October 22, 2015

Subject: Transmittal of Final Sampling and Analysis Plan Addendum 7
Smokey Mountain Smelters Site – Task Order 047; Contract No. EP-S4-08-03

**Addendum 7 to Sampling and Analysis Plan
for the Remedial Investigation / Feasibility Study of
Smokey Mountain Smelter Site, Knoxville, Knox County, Tennessee
(Dated April 2011)**

FIGURE 1
Proposed
Soil Samples

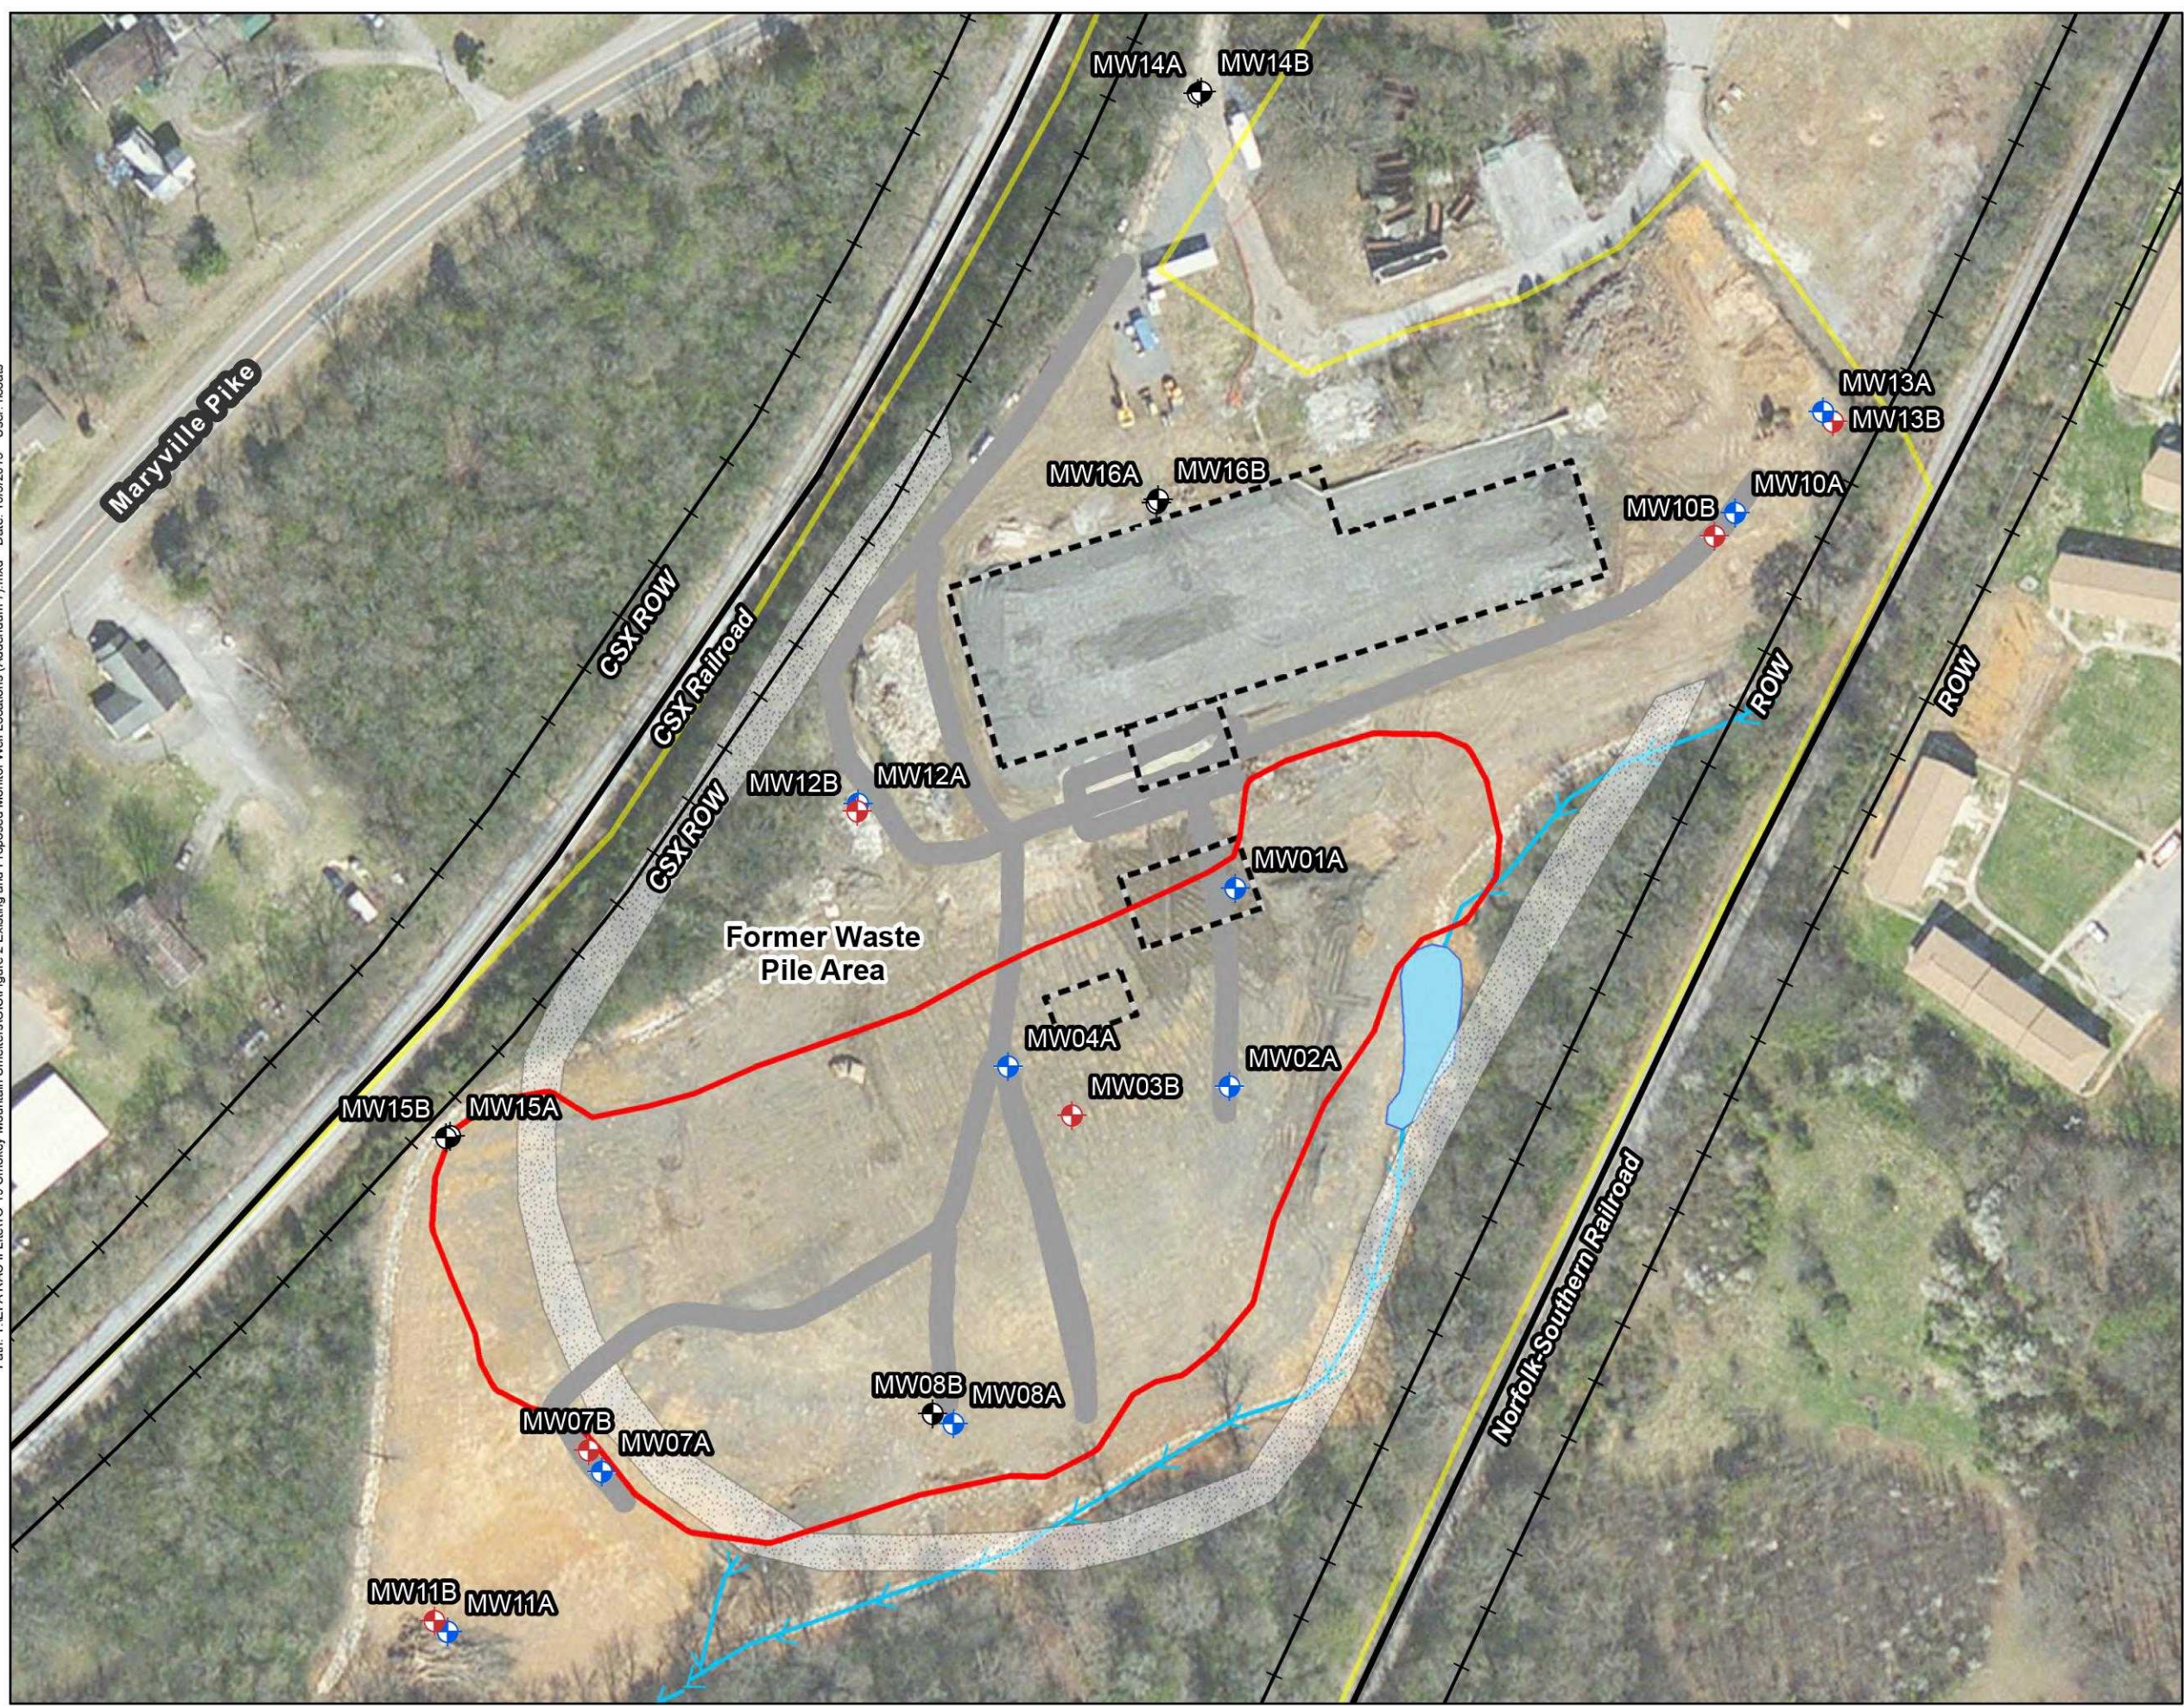
Subsurface soil sampling shall be conducted around the vicinity of the Former Settling Ponds which lies in the center of the site and the eastern boundary of the installed cap area and surface and subsurface soil sampling will be conducted at the former processing plant (Figure 1). Samples shall be collected using a rotasonic drill rig in order to penetrate the various types of debris beneath the surface. 44 samples shall be collected from the subsurface soil to delineate the vertical extent of contamination and attempt to locate a possible continuing source of contamination. All soil samples will be collected in accordance with the SESD Operating Procedure for Soil Sampling (SESDPROC-300-R1) and based on the XRF screening value.

Samples will be collected from the locations shown on Figure 1.

The locations where both surface and subsurface soil are planned to be collected are designated on the Figure 1.

FIGURE 2
Existing and Proposed
Monitor Well Locations
(Addendum 7)

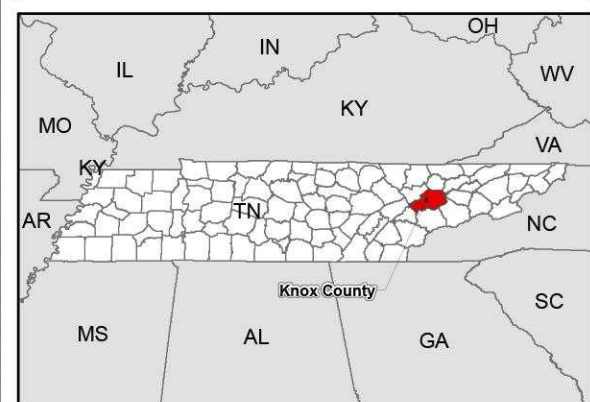
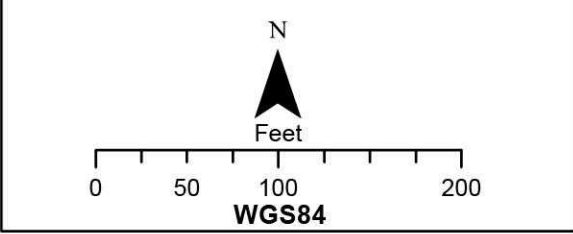
Figure 2 depicts the proposed drilling locations. All proposed wells, including MW8B, allow for contemporaneous potentiometric surface gauging and comparative chemical analysis of shallow groundwater and deeper groundwater present in bedrock fractures. Well pairs MW14A/B, MW15A/B, and MW16A/B are located to improve lateral spacing with respect to the current groundwater flow axis in an effort to refine the gradient induced potentiometric head model, outside the lineated arrangement provided by the current array of monitoring wells.

After newly installed wells have been developed a synoptic round of water levels should be performed on all monitor wells throughout the site. Groundwater samples shall be collected from each of the seven newly installed shallow monitor wells shown on Figure 2 in this Addendum 7. Samples will be submitted to EPA Region 4 ASB or the designated CLP Laboratory for analysis of TAL Metals and alkalinity. Groundwater samples shall be collected according to *SESDPROC-301-R3, Groundwater Sampling* and follow the procedures below:
